Recall Campaign

March 2020
FL801AB
NHTSA #18V-877 (School Buses)
#18V-878 (Non-School Buses)
Transport Canada #2018-691 (School Buses)
#2018-692 (Non-School Buses)

Subject: TBB Saf-T-Liner C2 Roof Header Adhesive

Models Affected: Specific Model Year 2017-2019 Thomas Built Buses Saf-T-Liner C2 buses manufactured July 1, 2016, through June 8, 2018.

Figure 6: 2-10 Box Screw Locations

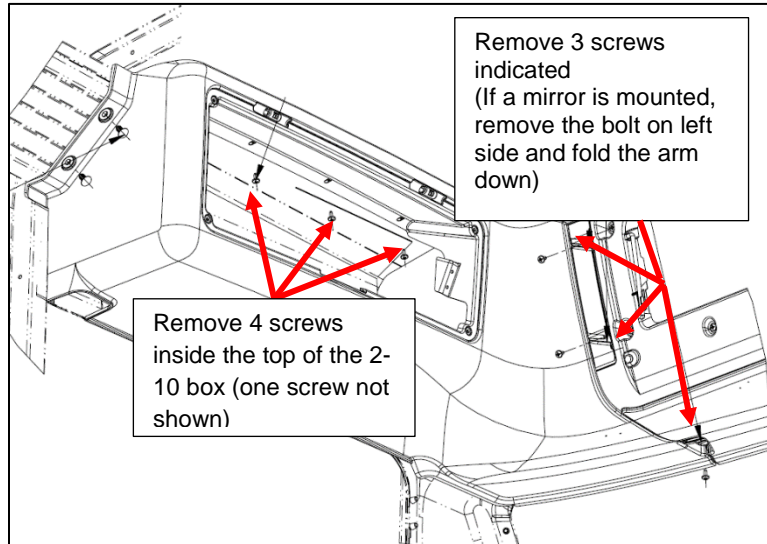
10. Remove the screws from the 2-10 box as indicated in **Figure 6**. Retain for reinstallation.
11. Remove the panel at back of the 2-10 box. Pull it up from the channel it sits in, then fold the corner to remove.

Figure 7: First Rafter Screw Installation

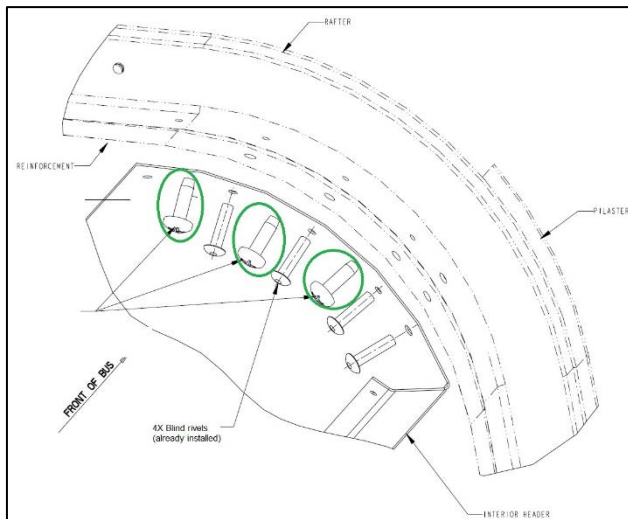
14. On the first rafter on one side of the bus, install 3 screws between the existing rivets. Drill a 7/32-inch hole for each screw then install the screws. See **Figure 7**. Repeat on the first rafter on the other side of the bus.

Figure 8: Screw Installation on Remaining Rafters

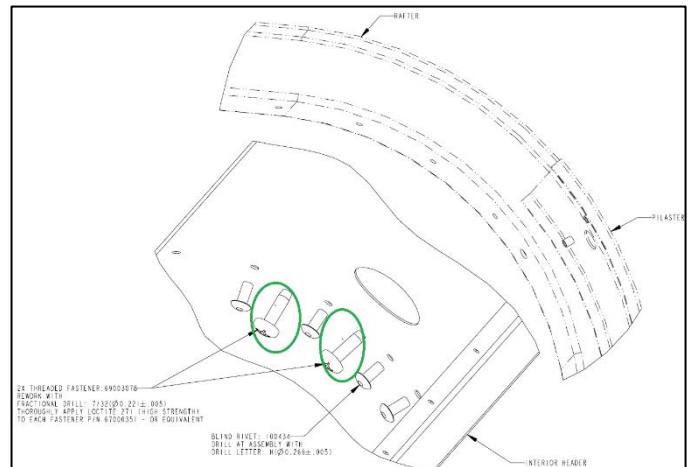
15. Install 2 screws on all remaining rafters on both sides of the bus. See **Figure 8**.
16. After installing screws on all rafters, reinstall the entrance door cover and the 2-10 box by reversing steps 2-13 above.

4. Move hoses and wiring aside and drill two 7/32 inch pilot holes located as shown in **Figure 8** and **Figure 15**.

5. Install screws in the locations as shown in **Figure 8**.
6. Move hoses and wiring back into place and make sure there are no kinks or leaks and that no harnesses were unplugged.
7. Reinstall the A/C cover with the screws removed earlier.
8. Remove the chocks from the tires.

Figure 11: A/C Cover Screw Locations (Front and Sides)

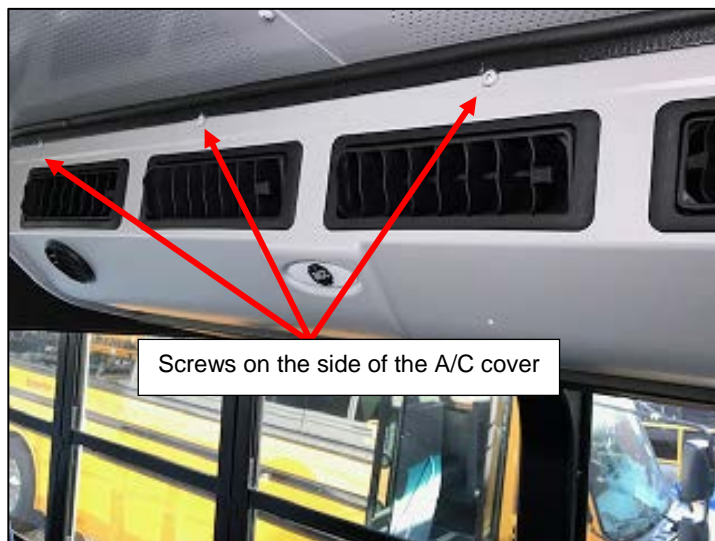
1. Remove the A/C cover by removing screws on the front, sides, and underneath. Retain for reinstallation. See **Figure 11** and **Figure 12** for screw locations.

Figure 14: Screw Installation Location

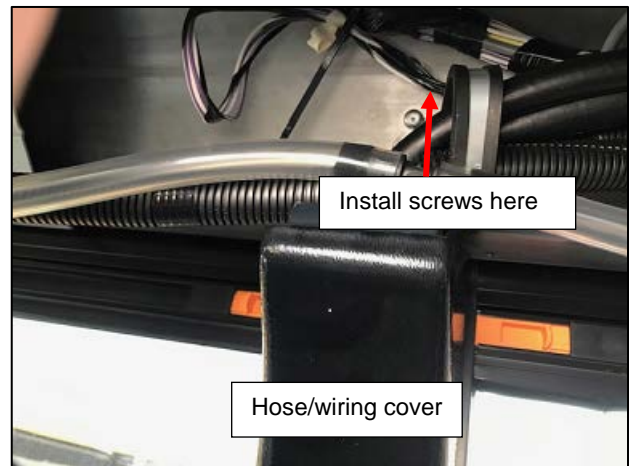
2. Gently remove cover. See **Figure 13**.
3. At the back, underside of the A/C unit and above the plastic cover for wiring and hoses coming from the floor, install two screws. See **Figure 14**.
